**ELECTRONICS  
INSTALLATION  
AND  
MAINTENANCE BOOK**

**SONAR**

**Change 5: February 1967 (0967-000-0035)**

Figure 1

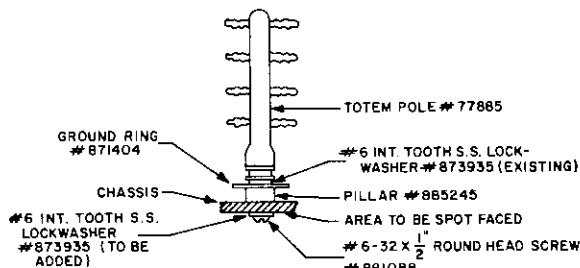
Several recent instances of "double keying", "short transmission sector", "keying lockout", etc., have been traced to an improper connection between the JP terminal post ground ring and chassis ground in the keying chassis.

Proper equipment operation was restored by the installation of an additional lockwasher (Sangamo part No. 873935) FSN N5310-806-9493 under the head of the JP terminal post mounting screw, as shown in figure 1.

The No. 6-32 X 1/2" mounting screw must be removed while holding the JP terminal post firmly against the chassis so that the "pillar" and "ground ring" lockwasher will not be disturbed. Remove all paint from the area under the screwhead. The added lockwasher is installed directly under the head of the mounting screw and the entire assembly should be firmly secured.
